GULF POWER SMITH UNIT 3 Site Certification Application

Sufficiency Responses

RE: Gulf Power Company;
Lansing Smith Unit 3;
Responses to Agency Sufficiency Comments
DOAH Case No. 99-2641EPP; Application No. PA99-40

PLOT PLAN AND GRADING PLAN WITH
CROSS SECTION LOCATIONS

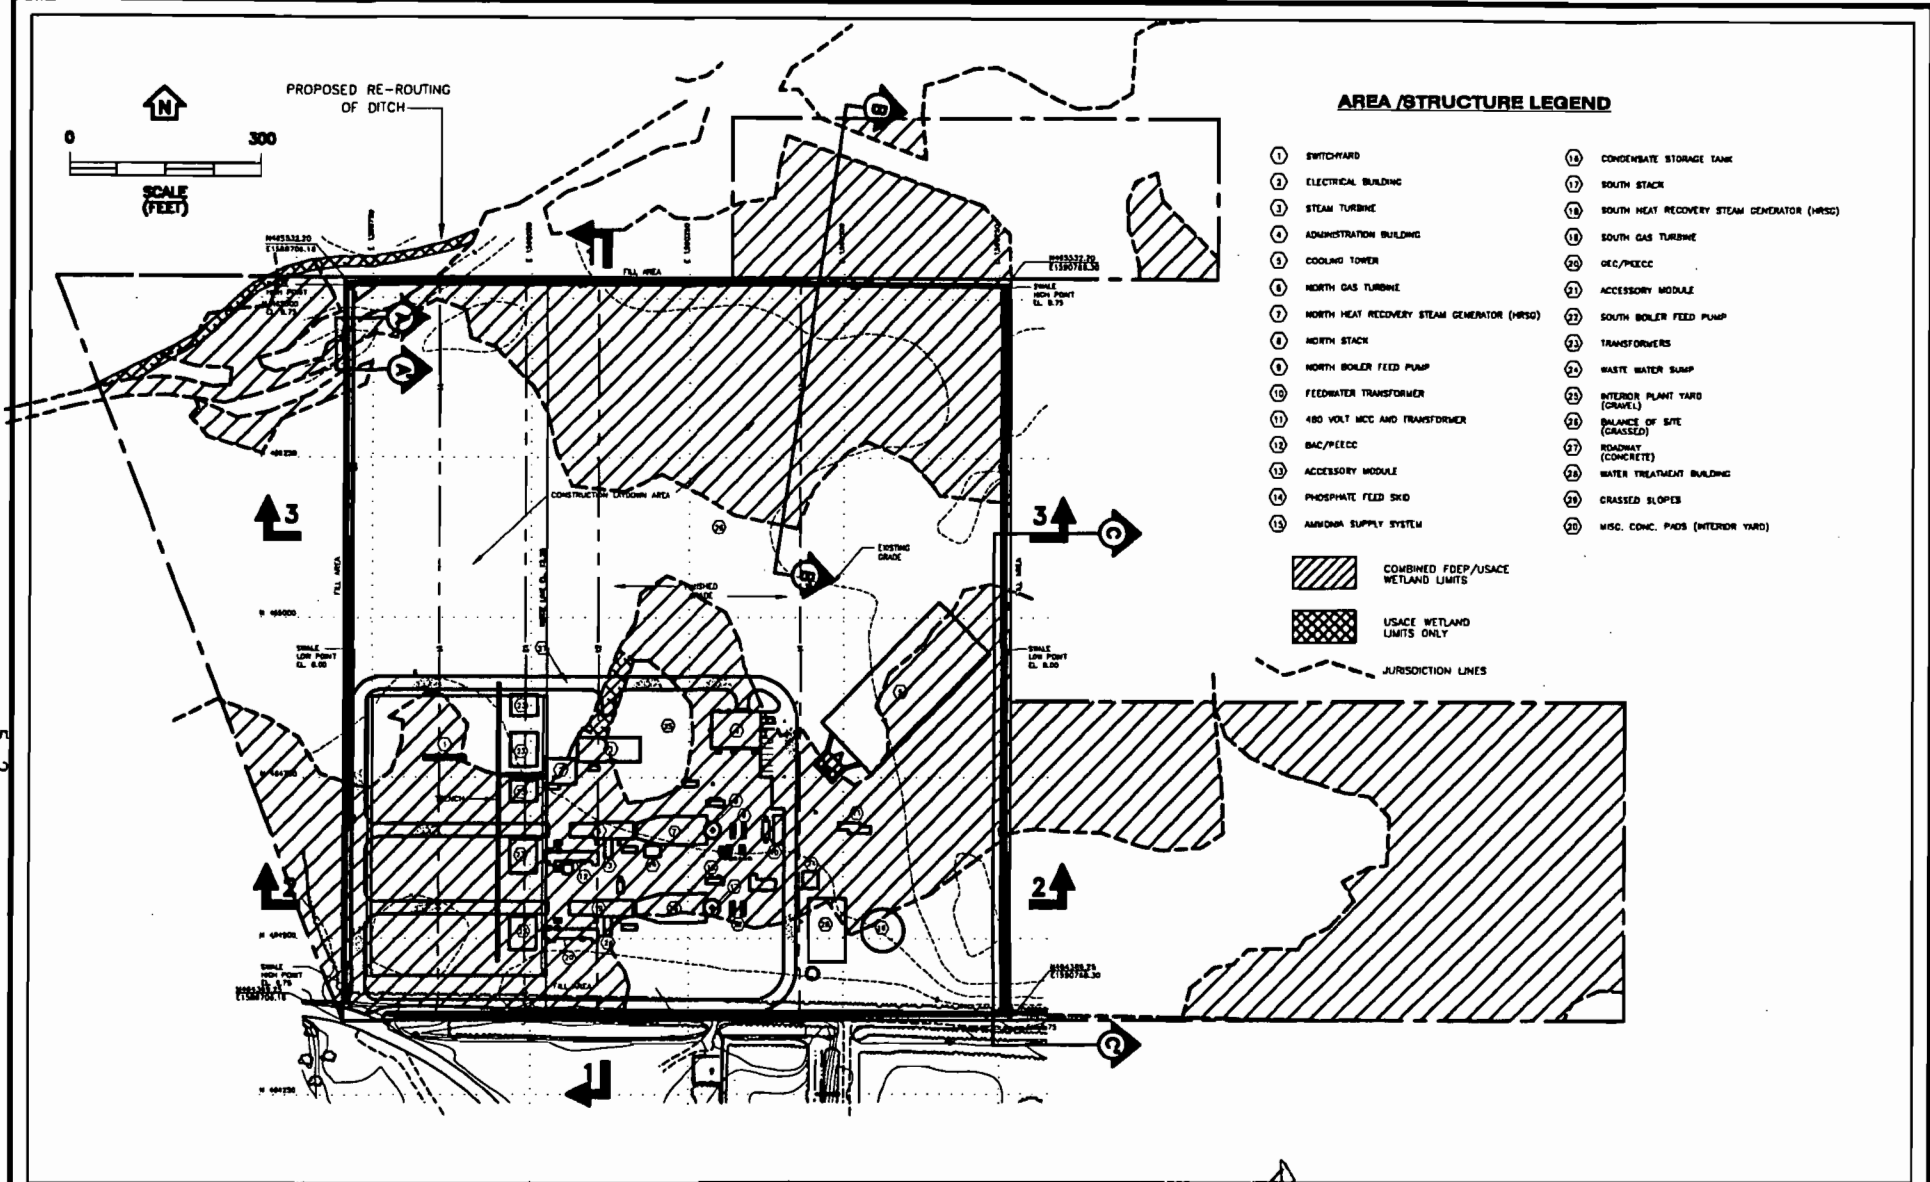
Provide scaled plan/cross-sectional view drawings which show the project layout in relation to wetland areas. Full size and 8 1/2" x 11" drawings should be provided.

Full-size plan and cross-section view drawings are provided in Attachment H.
